# **EFNA Steering Committee**

## **Meeting Summary**

### **Lacy Road**

### **Fitchburg Community Center to S. Syene Road**

LEGEND

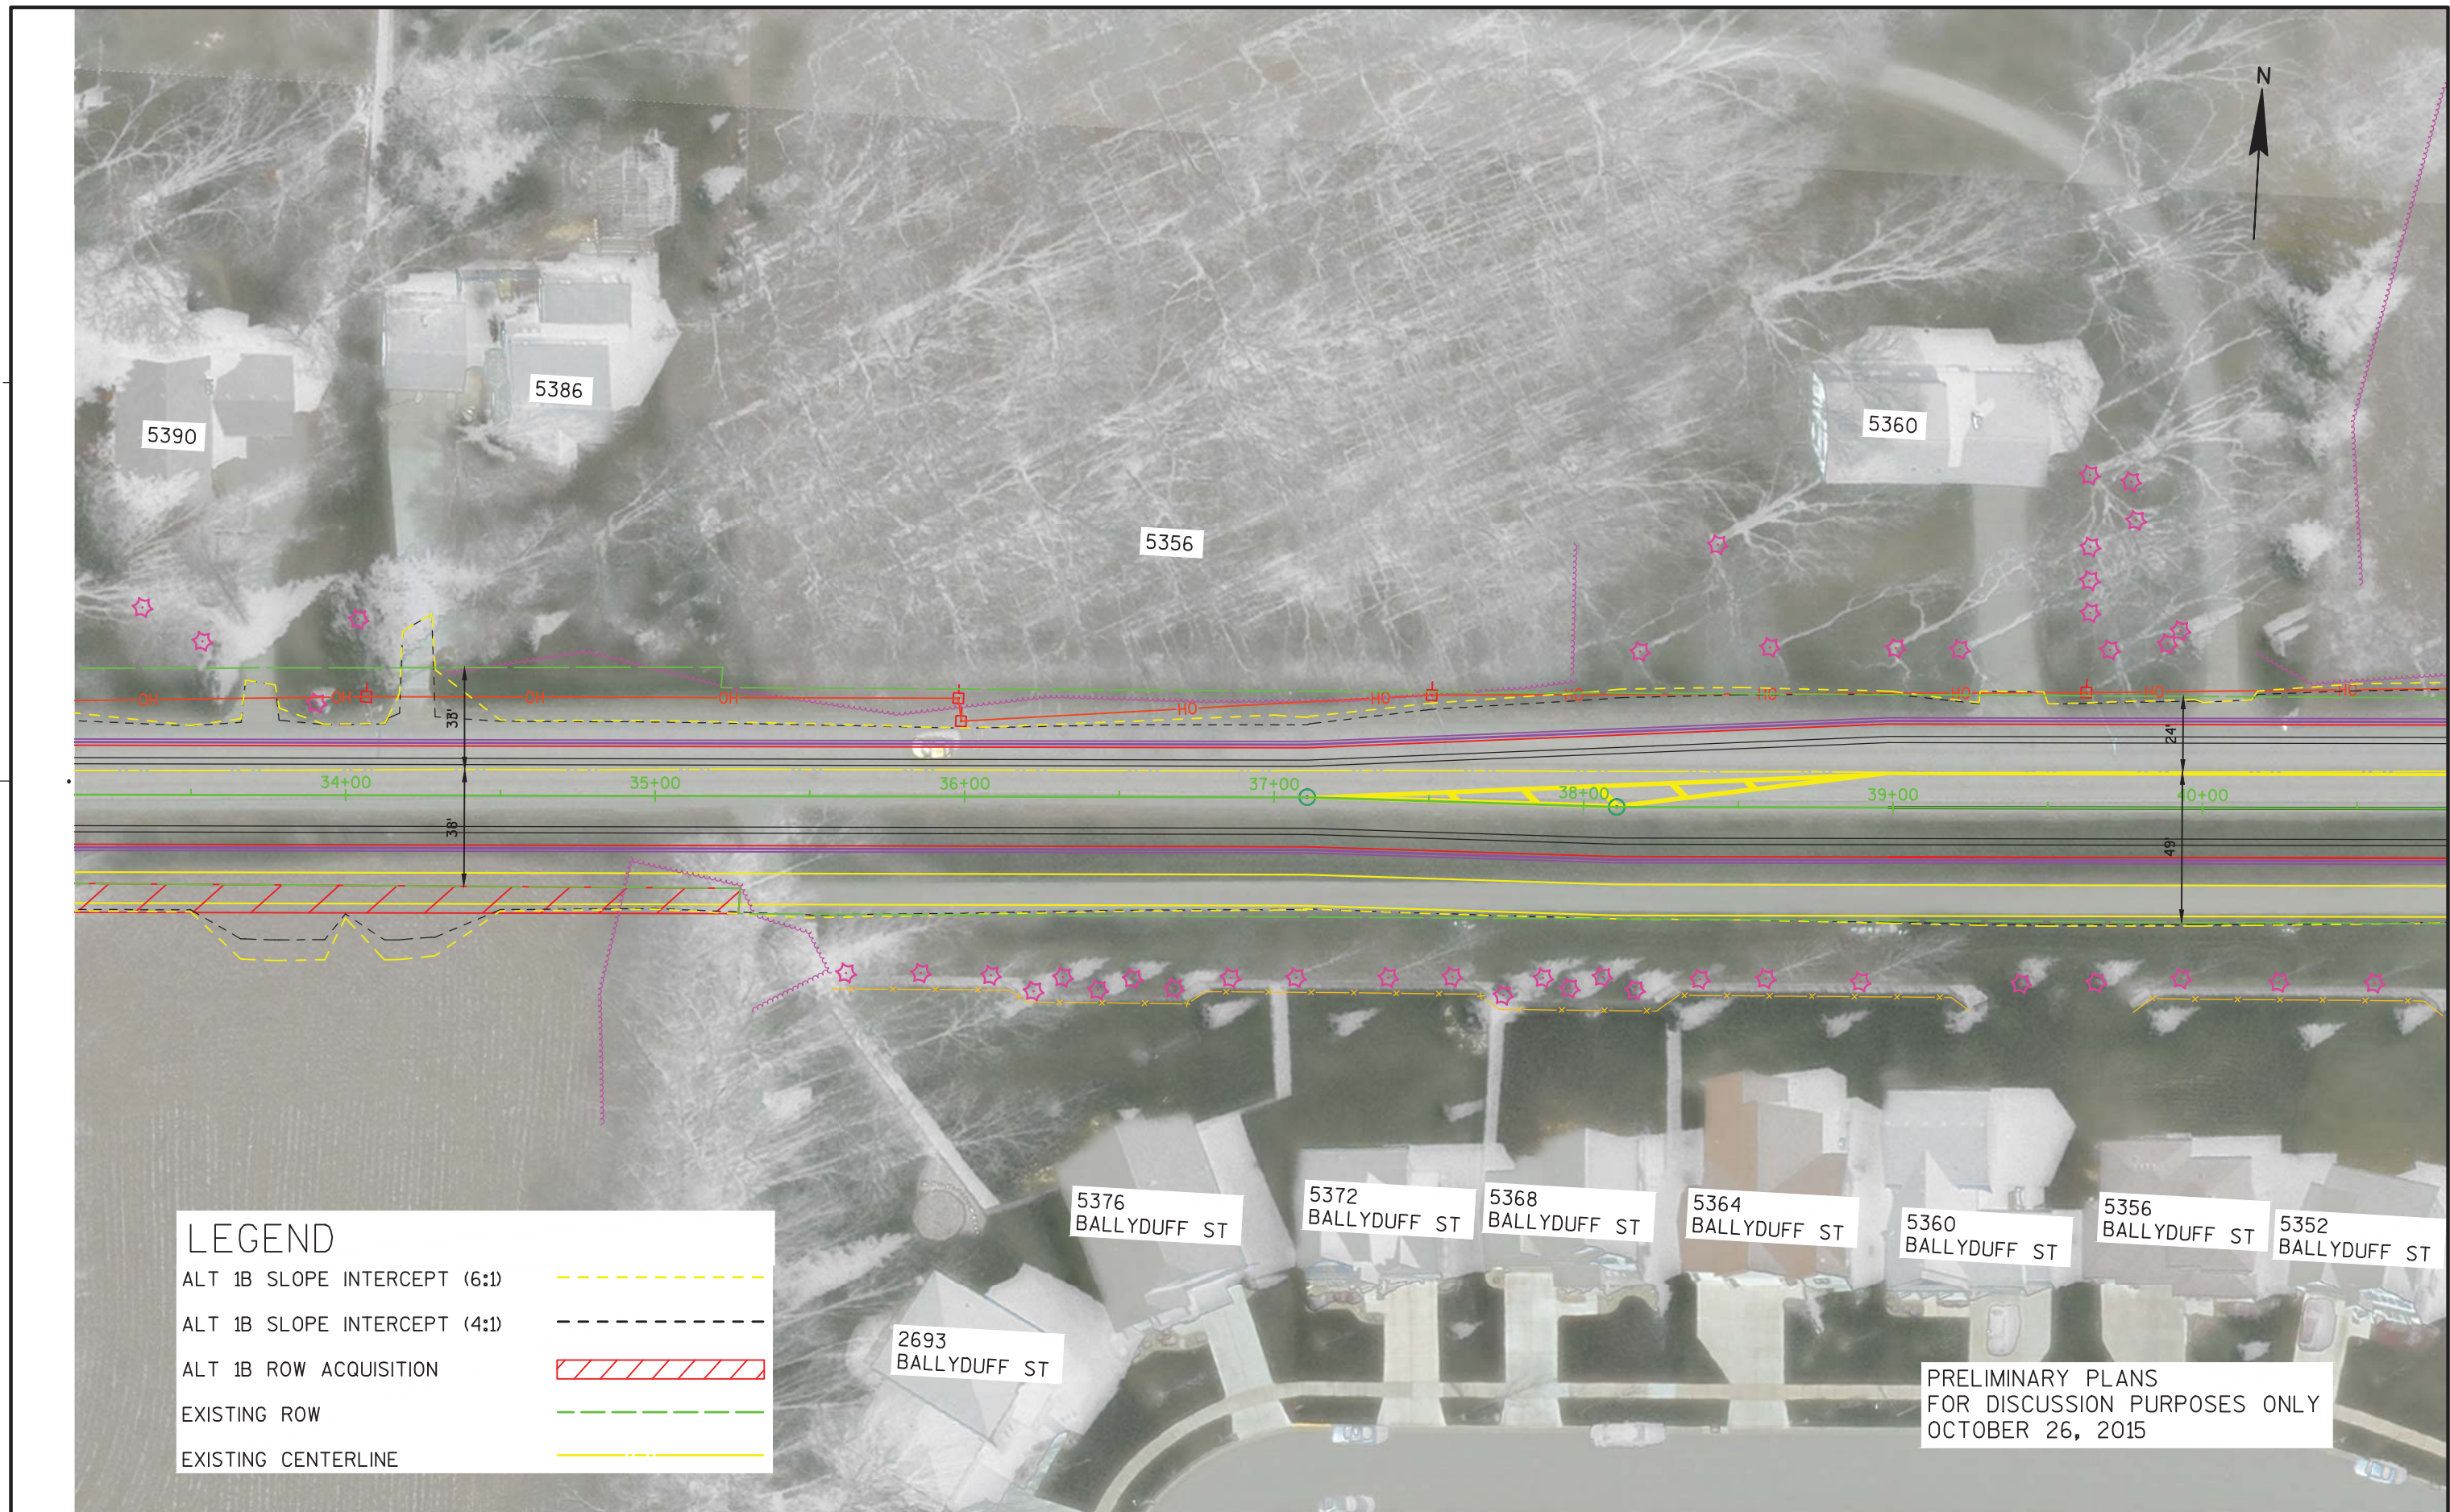
Troy explained that preliminary plans have been prepared from the west project limit east to approximately Waterford Glen. The aerial photos with the proposed linework for the road and path are attached. The initial alignment was established by maintaining the existing road centerline and placing the shared-use path on the south side. Ahna stated that by doing this, it will mean more acquisition on the south side of Lacy Road.

Troy described that the plans show 2 different lines for the slope intercept; one is based on a 6:1 slope and the other a 4:1 slope. Ahna mentioned that the affected homeowners would be contacted to discuss their preference for the slope grades. The 6:1 is less steep, but extends further onto private property to match back in. A 4:1 slope is steeper, but it could avoid impacts to trees or landscaping.

6. Discussion of project impacts – Ahna commented that the initial road alignment (which maintained the existing road centerline) is in conflict with the existing sanitary sewer line. She pointed out that the existing sanitary manholes fall within the proposed curb and gutter. That presents a problem for the manhole structure itself, as well as for the maintenance efforts to clean and repair the sanitary line. The road could be shifted to the south, but that would require even more right-of-way acquisition and would place the sanitary sewer line within the bike lane. Instead, Ahna is recommending the road to be shifted approximately 4' to the north to keep the sanitary sewer line within the 7' terrace between the road and the shared-use path. There was concurrence that it makes sense to shift the proposed alignment to the north to avoid an impact with the sanitary sewer.
